Addendum #002

April 28, 2026

New Jetson Center for Youth
Baker, Louisiana
Project # 08-403-04-02, F.08000078, 08-403-24-01, F.08000165

SHEET NUMBER
ES101

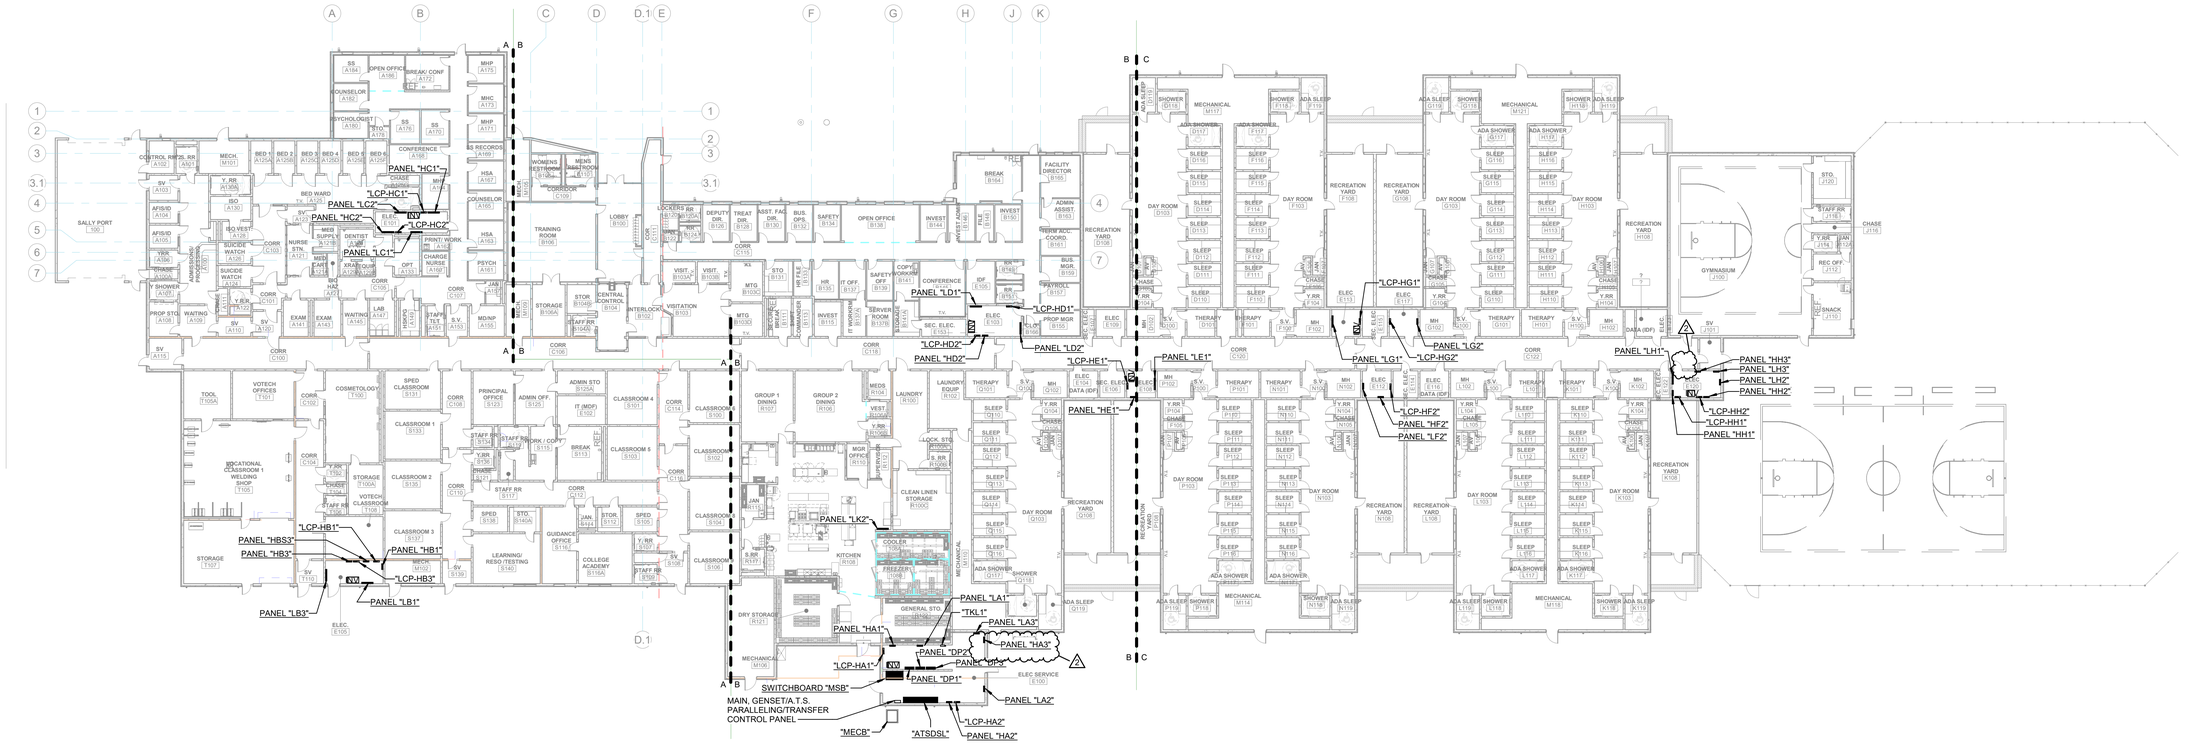
1. **SHEET ES101 – SITE PLAN ELECTRIAL**
    a. Make changes to the “Site Electrical Plan” as shown
2. **SHEET E100 – ELECTRICAL FLOOR PLAN - OVERALL**
    a. Make changes to the “Electrical Floor Plan - Overall” as shown

ELECTRICAL LIGHTING PLAN - SECTOR B

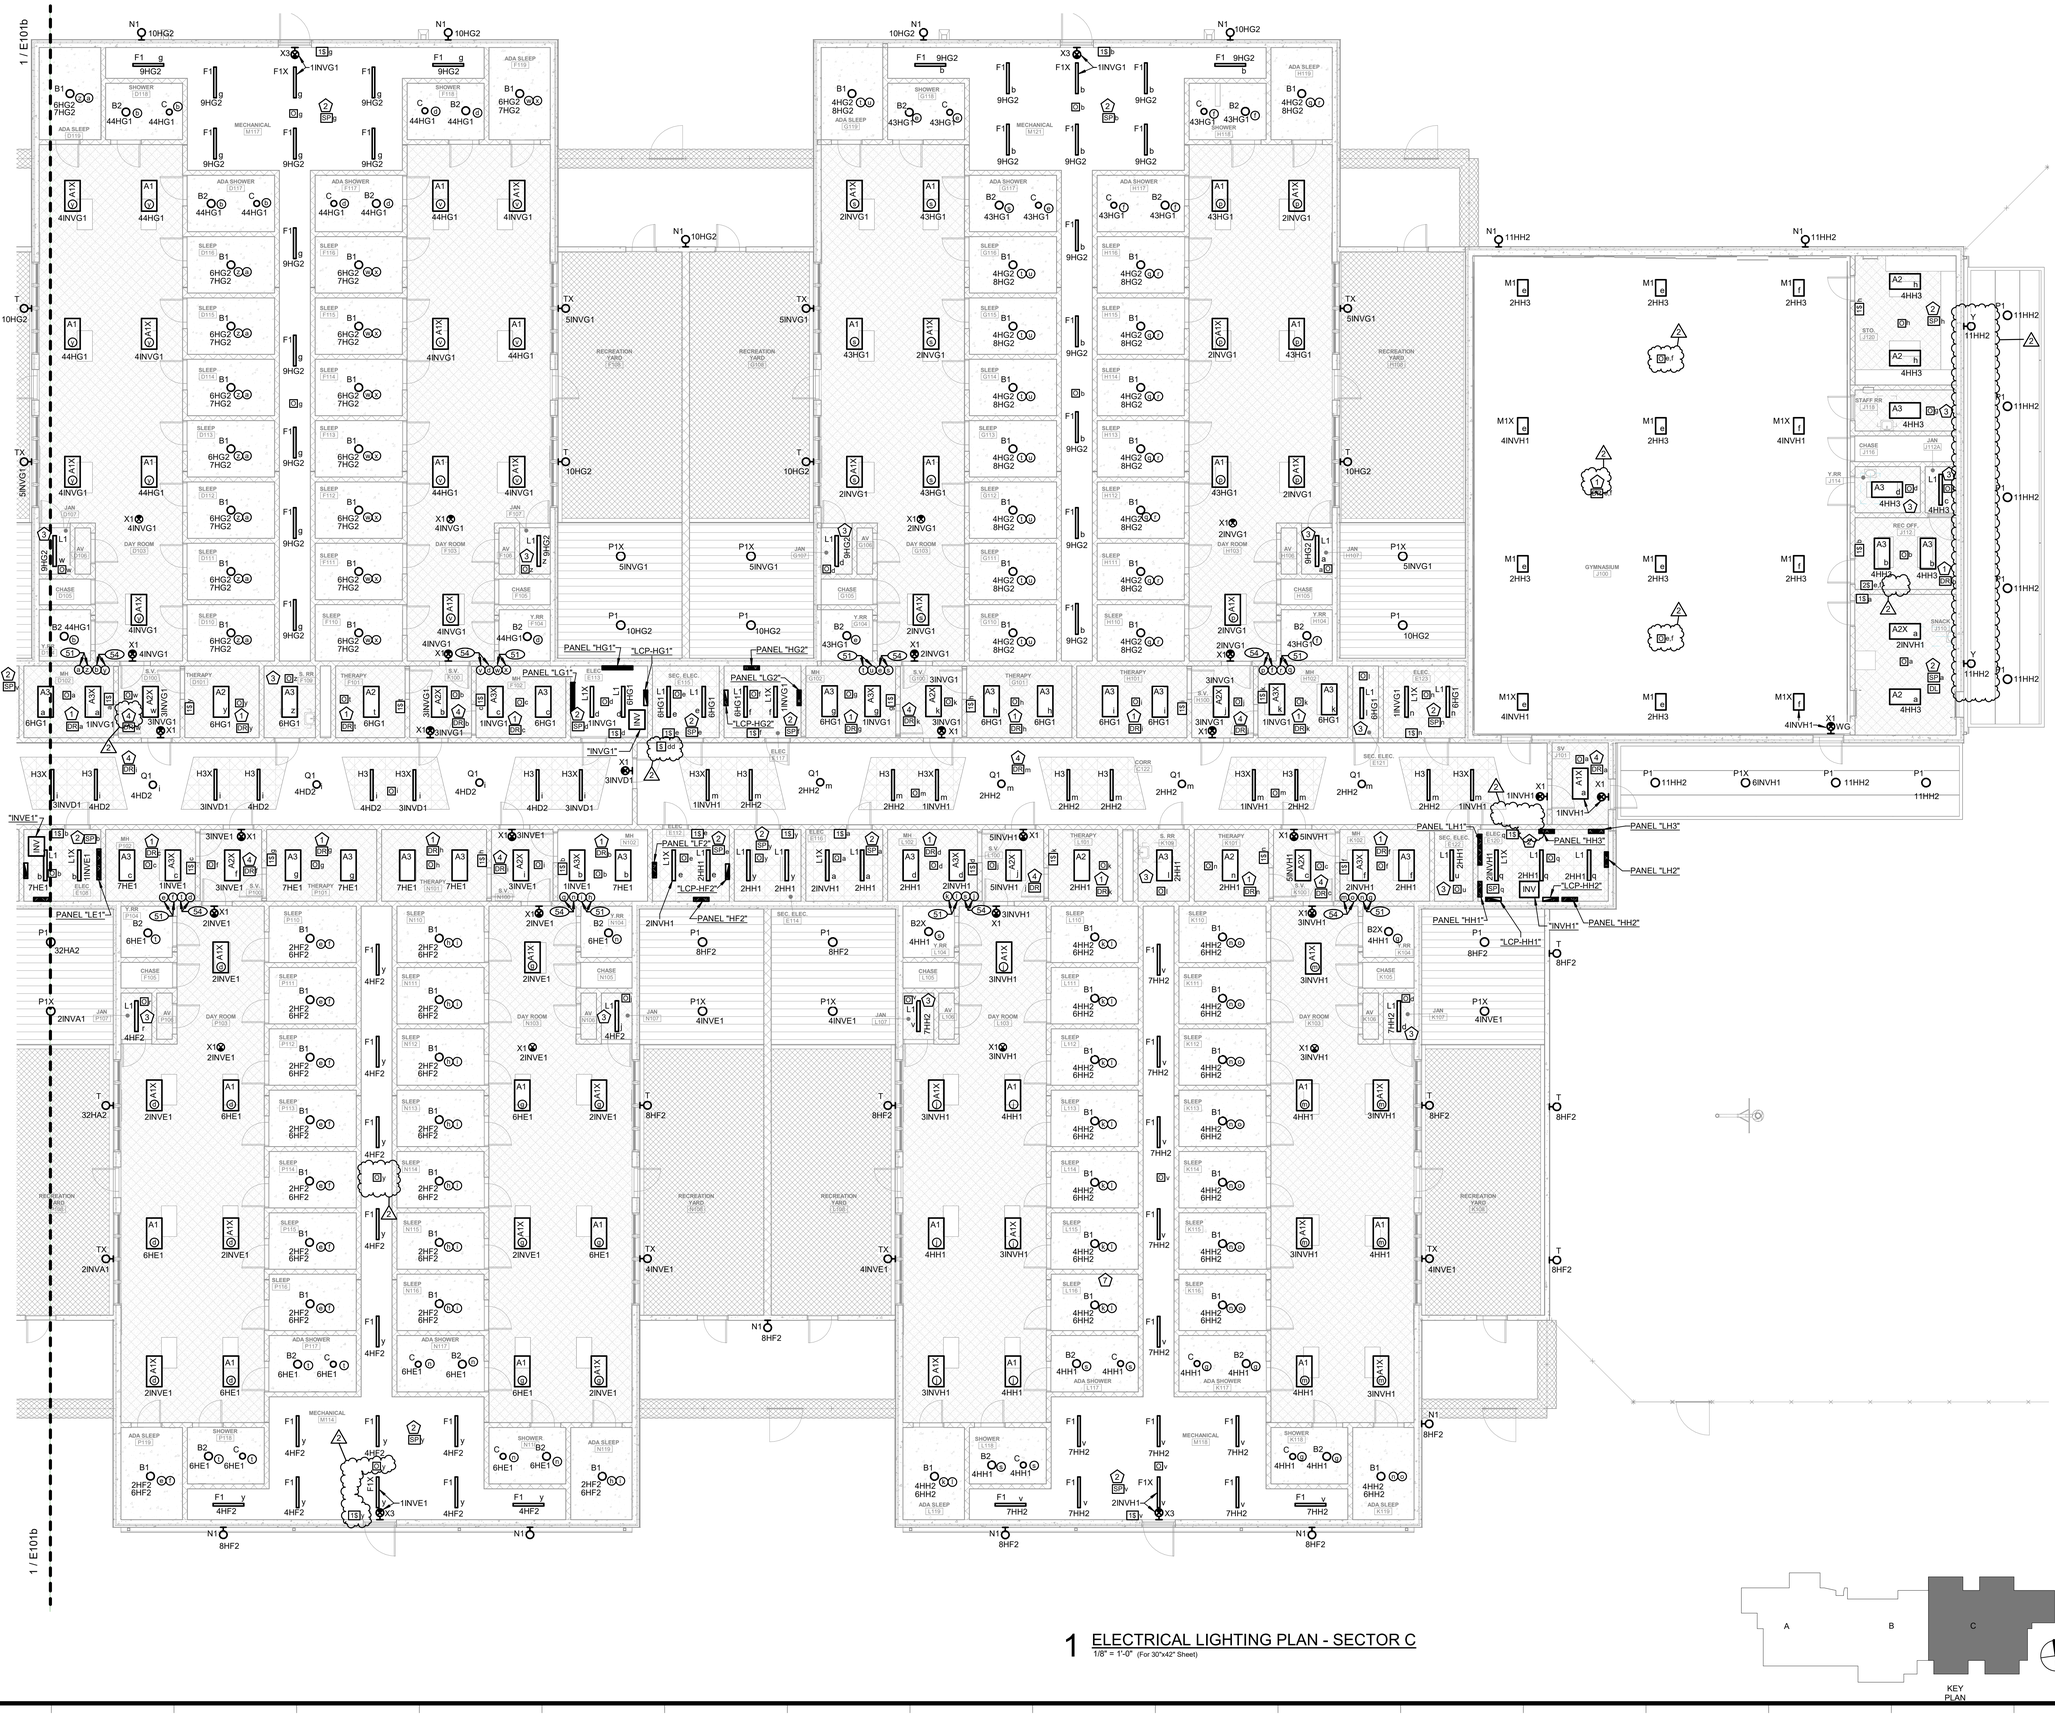
4. **SHEET E101b – ELECTRICAL LIGHTING PLAN – SECTOR B**
    a. Make changes to the “Electrical Lighting Plan - Sector B” as shown
5. **SHEET E101c – ELECTRICAL LIGHTING PLAN – SECTOR C**

ELECTRICAL LIGHTING PLAN - SECTOR C

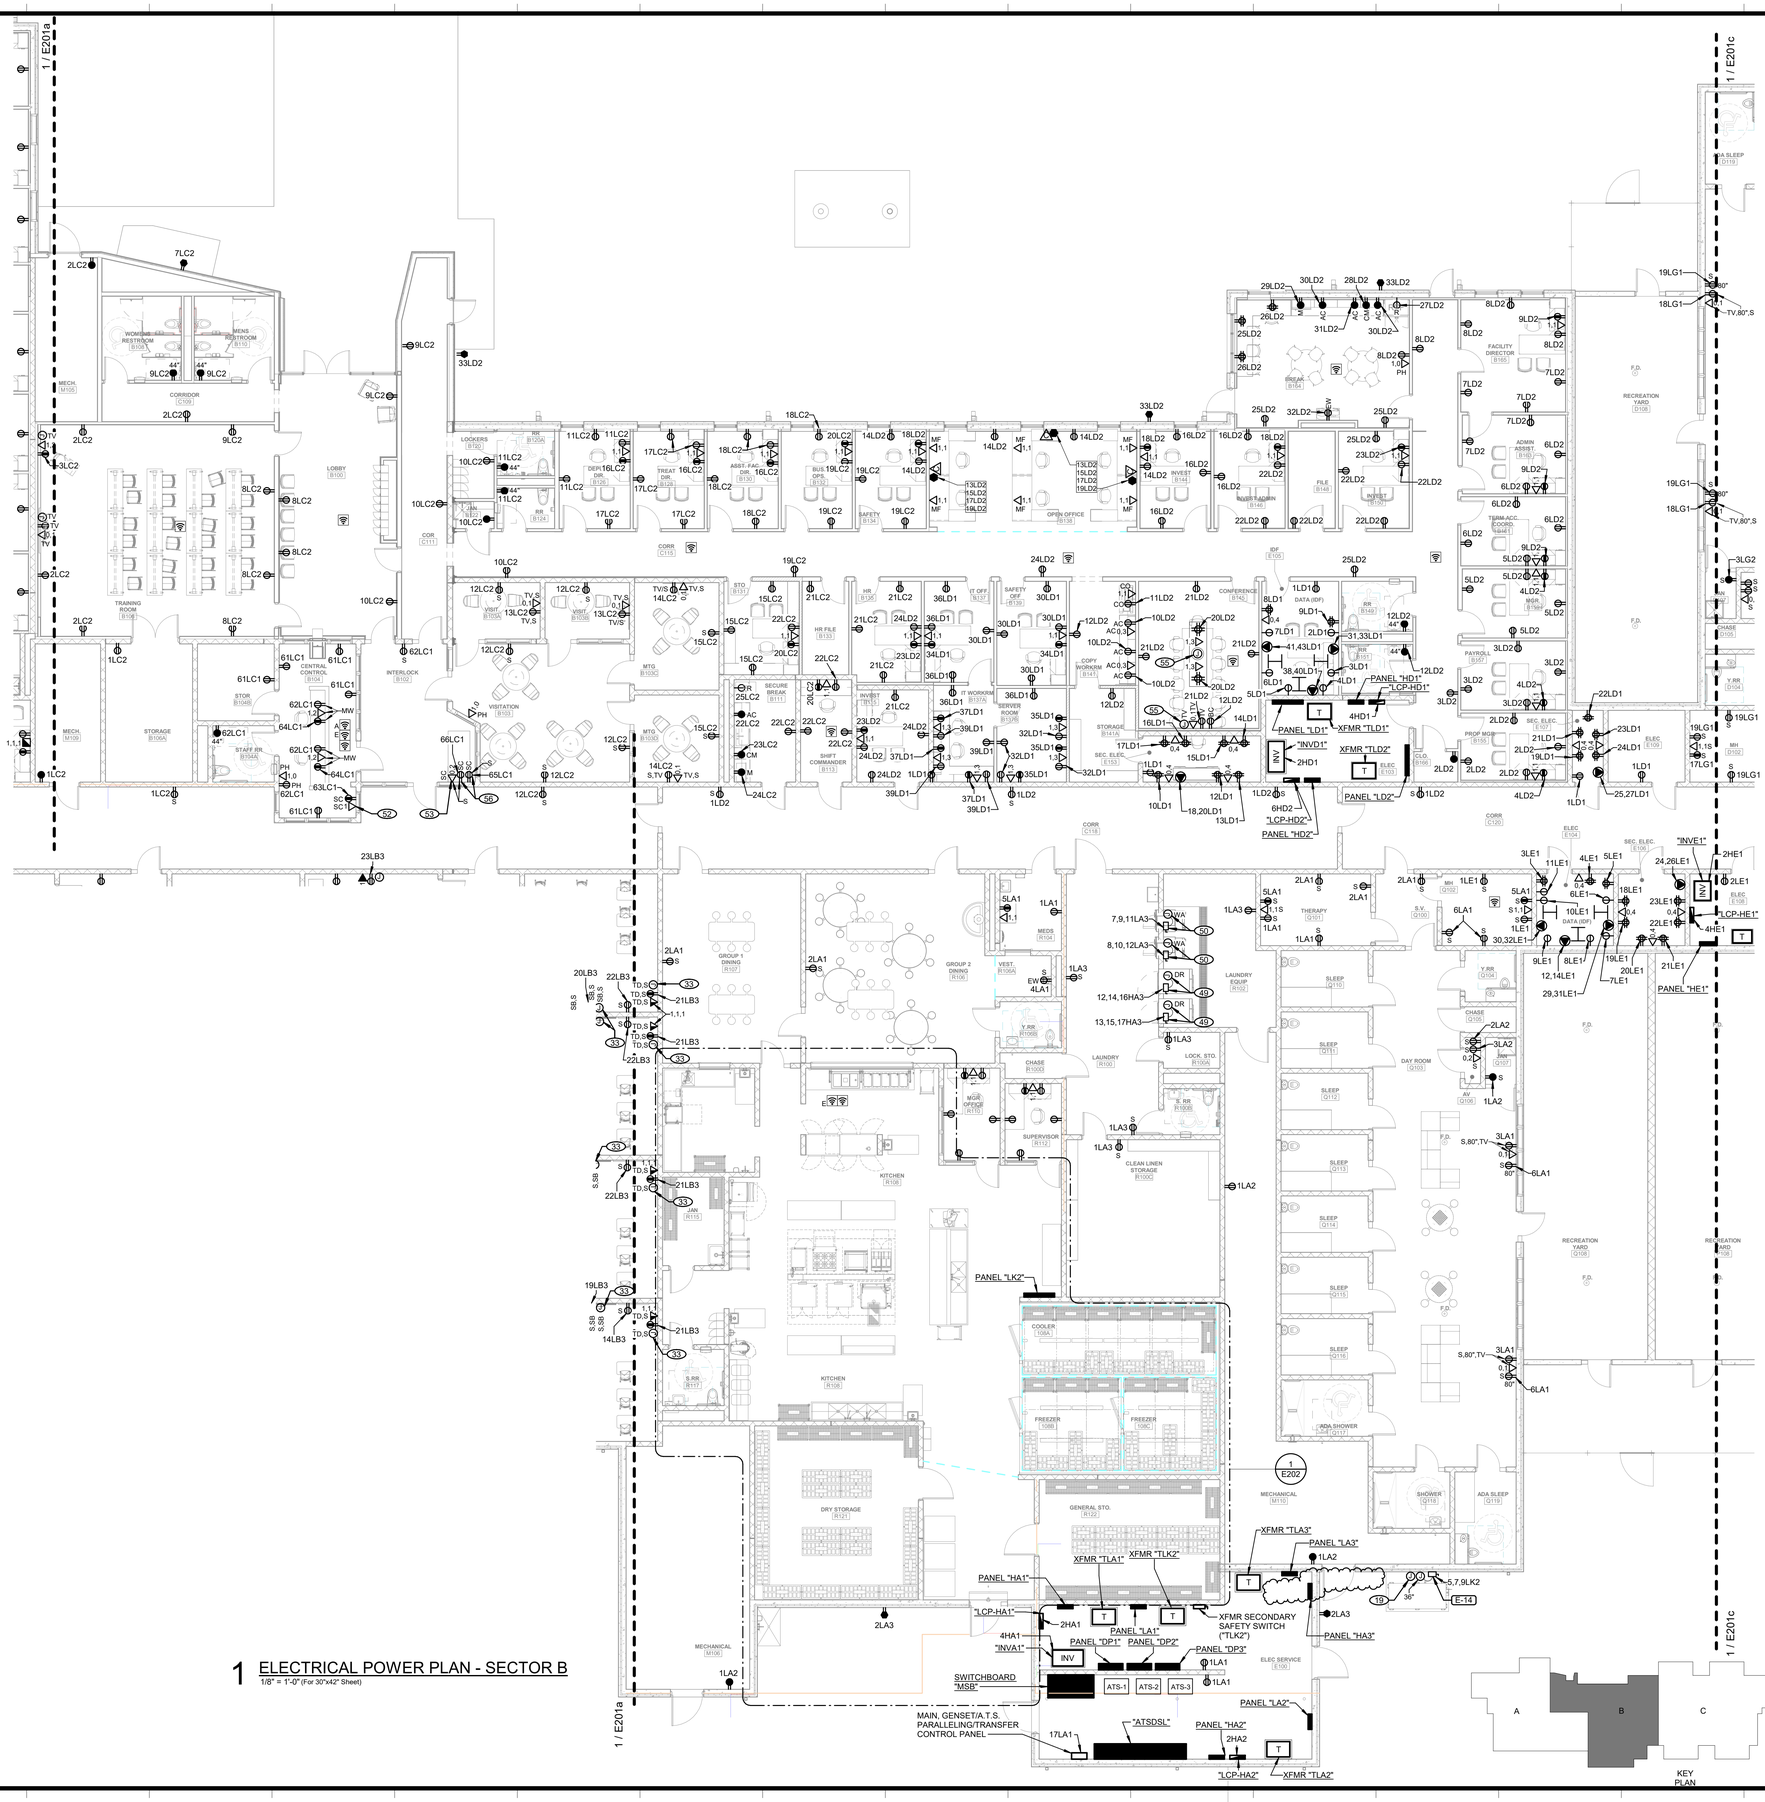
2. **RFI Question:** Sheet E101C - In Mechanical Room M114, is an occupancy sensor and low voltage switch required in this room?

a. Make changes to the “Electrical Lighting Plan - Sector C” as shown.
6. **SHEET E201b – ELECTRICAL POWER PLAN – SECTOR B**
    a. Make changes to the “Electrical Power Plan - Sector B” as shown.

Response: Yes. The missing occupancy sensor and low voltage switch is being added as a revision on Sheet E101C as part of this addendum.
